BLM Solar Energy Development Draft Programmatic EIS Comments  
9700 South Cass Avenue – EVS/240  
Argonne IL 60439

RE: Comments to Draft Programmatic Environmental Impact Statement for Solar Energy Development in Six Southwestern States

Lincoln County, Nevada has completed a comprehensive review of the Draft Programmatic Environmental Impact Statement for Solar Energy Development in Six Southwestern States (DPEIS) and provides the following comments thereto. Lincoln County has participated extensively in the National Environmental Policy Act (NEPA) process leading to release of the DPEIS for public comment. During the summer of 2009, Lincoln County, through the Bureau of Land Management's Nevada State Director, requested that proposed Solar Energy Zones in Delamar Valley, Dry Lake Valley (North) and in the vicinity of the East Mormon Mountains be included in the scope of the Programmatic Environmental Impact Statement for Solar Energy Development (PEIS). The Board of Lincoln County Commissioners believe that utility-scale solar energy development on BLM-administered land, if done in the right locations, at an appropriate scale and in a manner which avoids, minimizes and/or otherw

**Figure 1**  
**Lincoln County Recommended SEZ**  
**Within Ely Springs Cattle Allotment**

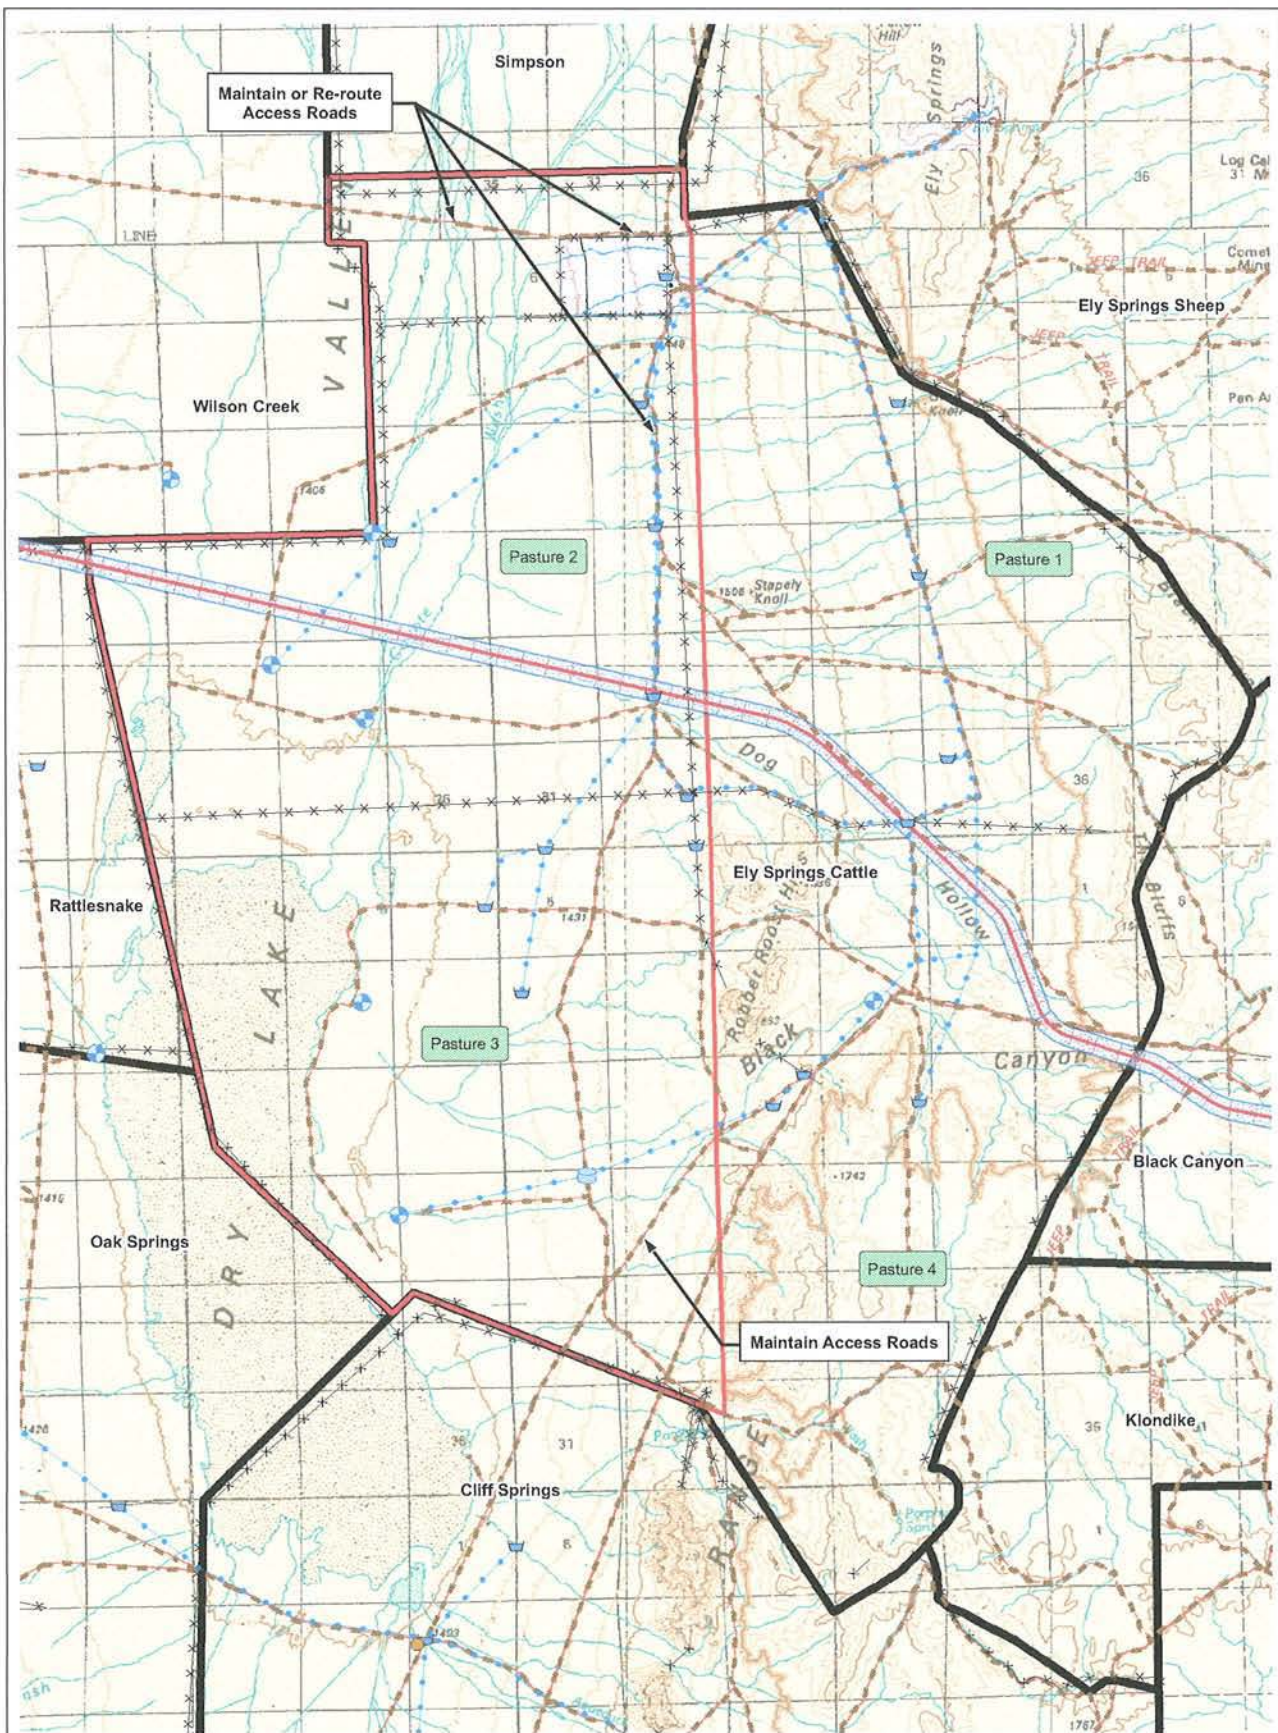
As shown on Figure 1, Lincoln County has identified an area within the Ely Springs Cattle Allotment portion of the Dry Lake Valley North SEZ. This above-mentioned area exceeds the 10,000-acre required maximum area per reasonably foreseeable transmission capacity. Therefore, designating the Delamar Valley SEZ as "lands excluded from utility-scale solar energy development" should have no impact on the overall feasibility of solar energy production within Lincoln County, nor should it encumber the renewable energy goals of the State of Nevada or the current Federal Administration based on the need for renewable energy and available transmission capacity.

1999 Harrison Street, Suite 2150  
Oakland, CA 94612  
Attention: Chief Financial Officer  
Telephone: (510) 550-8151  
Facsimile: (510) 550-8165

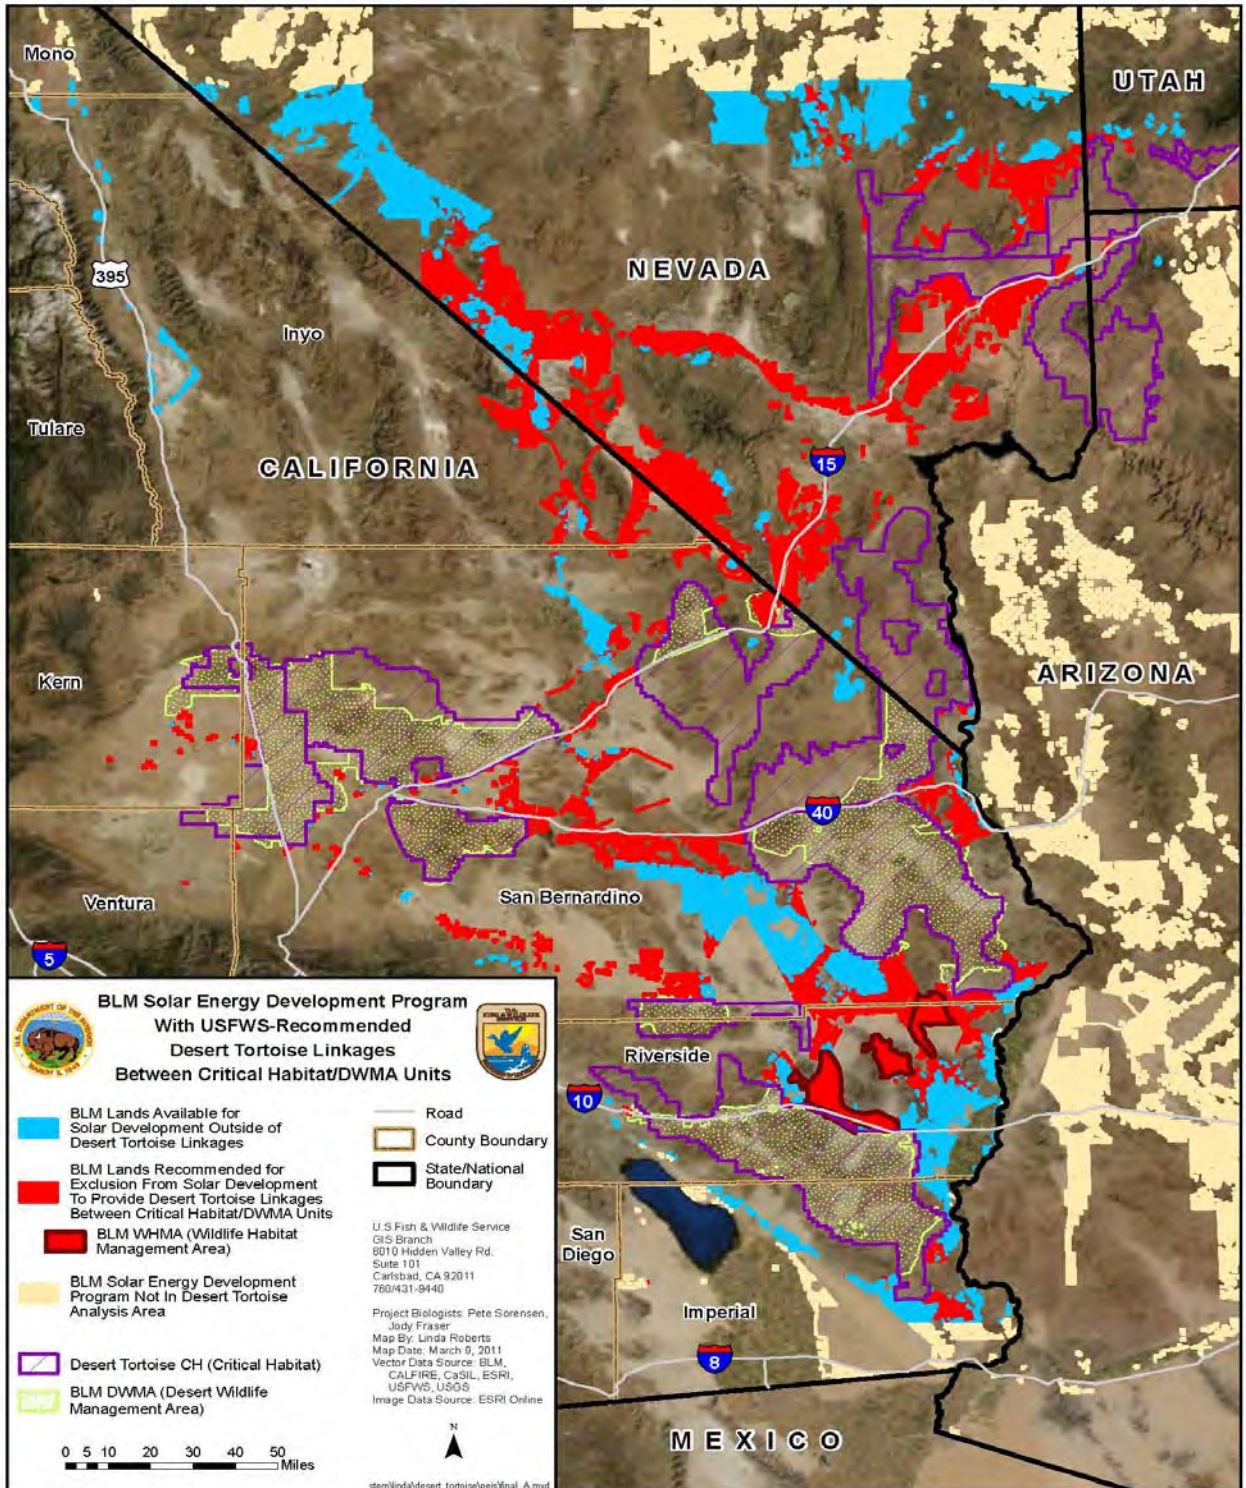
This figure depicts the USFWS proposal for the minimum linkage design (red) necessary for conservation and recovery of the Mojave population of the desert tortoise by connecting Desert Wildlife Management Areas (yellow mottled) and critical habitat units (purple hatched).

The lands in red are proposed for exclusion from solar energy development by the USFWS and are in addition to those the BLM has identified as excluded in the DPEIS.

# Greater Sage-Grouse Areas of Concern in Utah

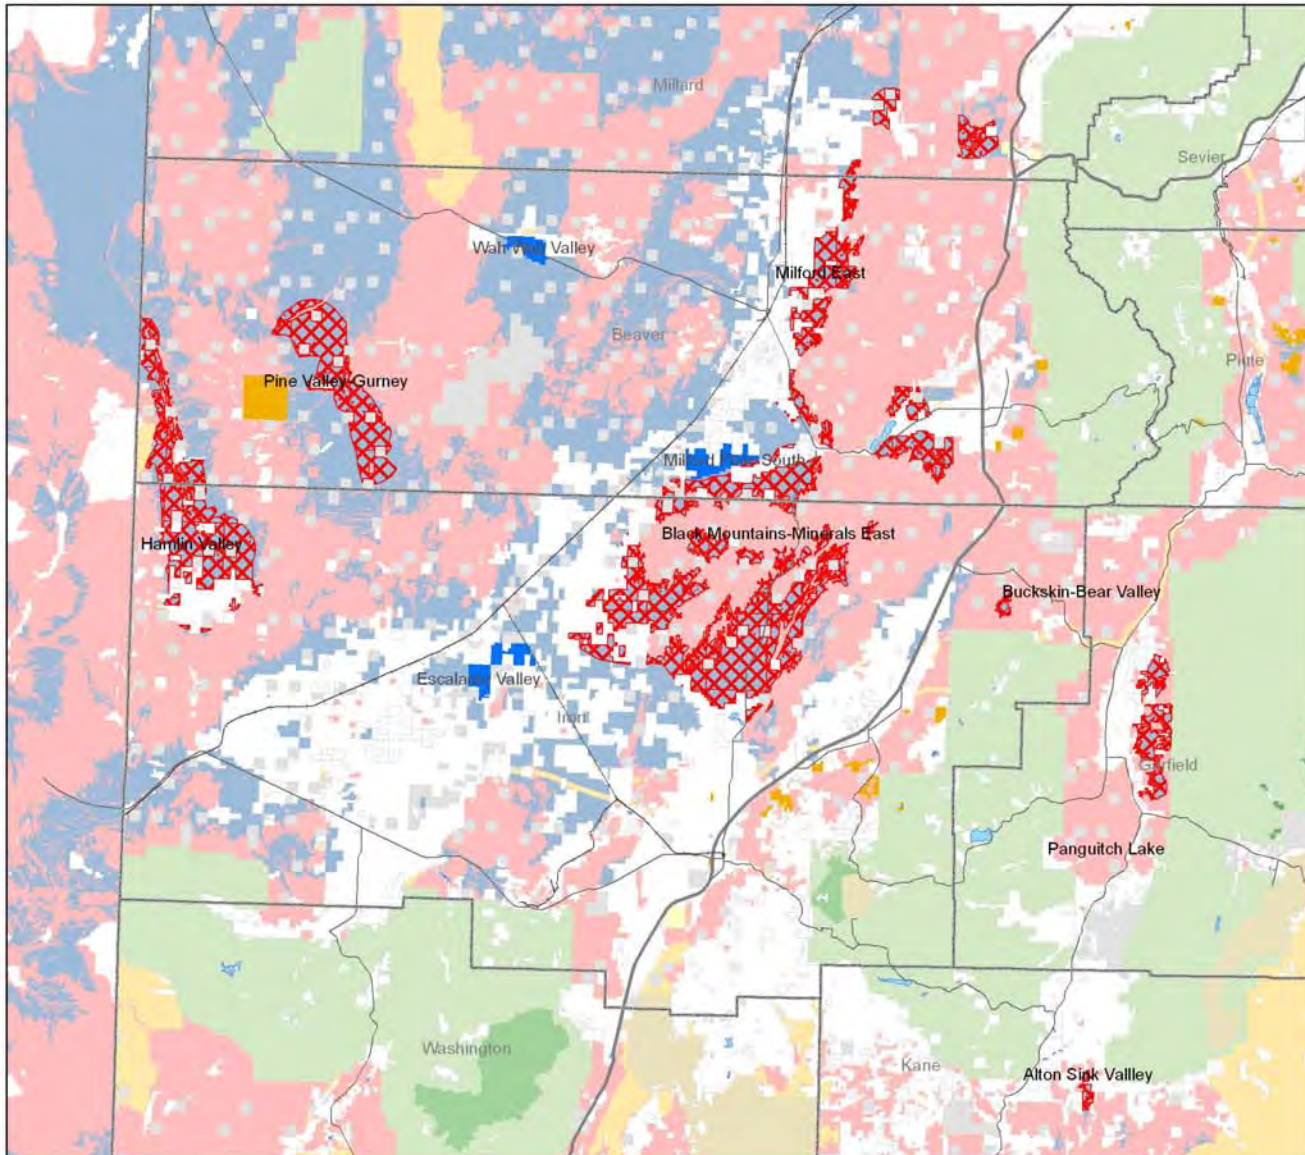
Greater sage-grouse areas of concern identified by FWS Utah Ecological Services Field Office for BLM Solar Energy Development Programmatic EIS. These crucial brood-rearing and/or wintering habitats lie within BLM's preferred alternative for solar development.

# Greater Sage-Grouse Areas of Concern in Utah

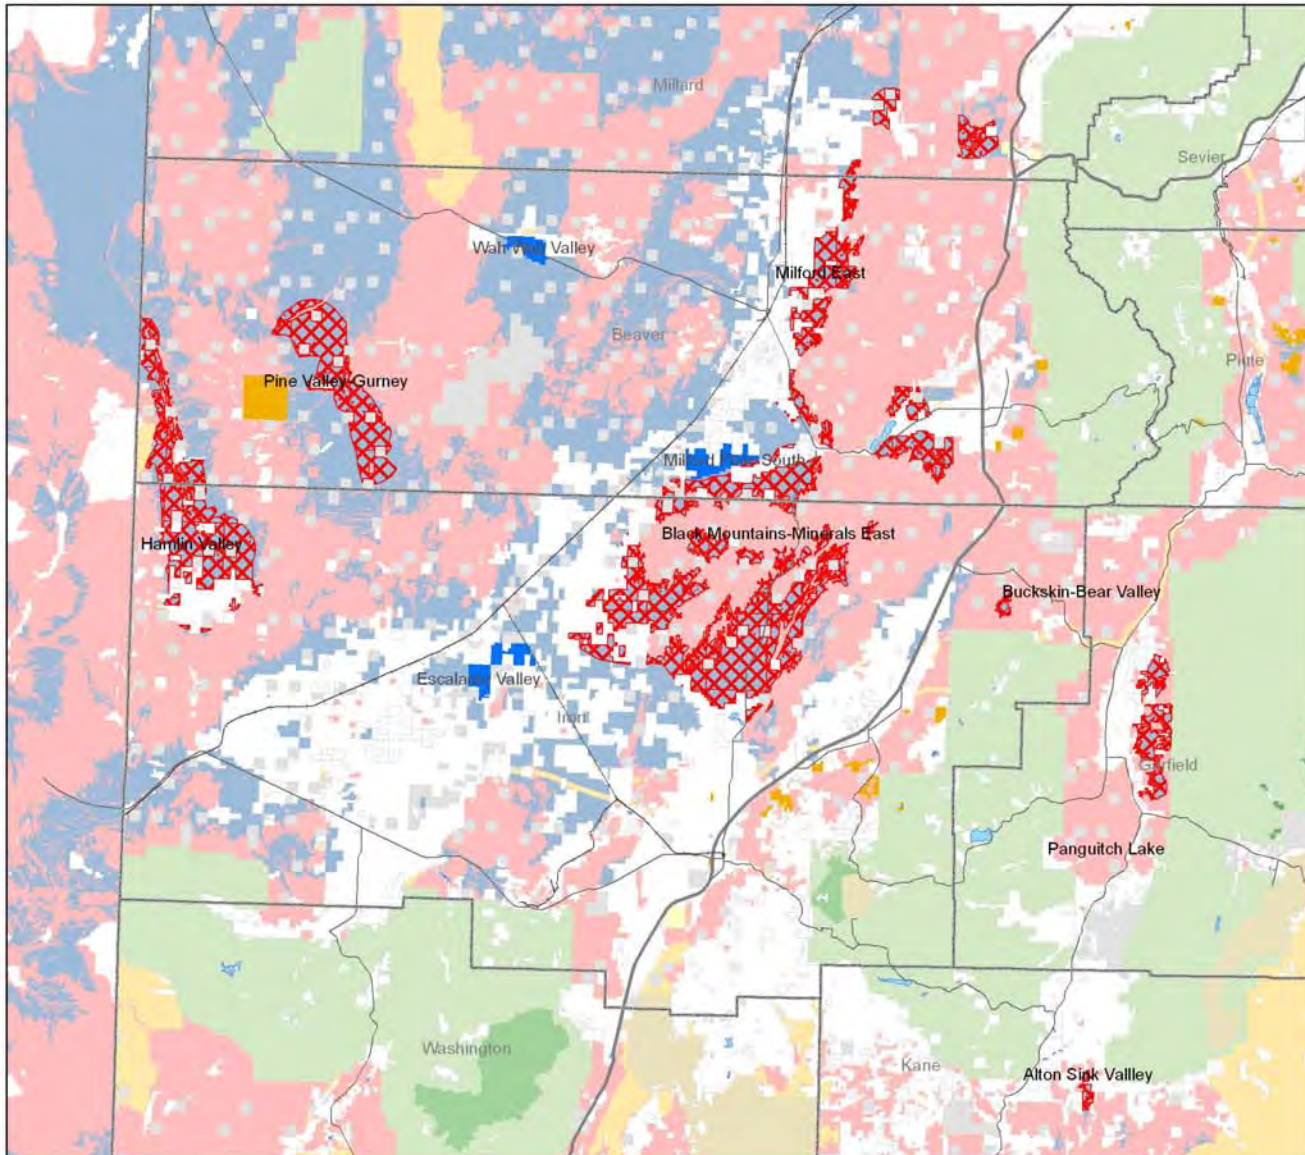
Greater sage-grouse areas of concern identified by FWS Utah Ecological Services Field Office for BLM Solar Energy Development Programmatic EIS. These crucial brood-rearing and/or wintering habitats lie within BLM's preferred alternative for solar development.
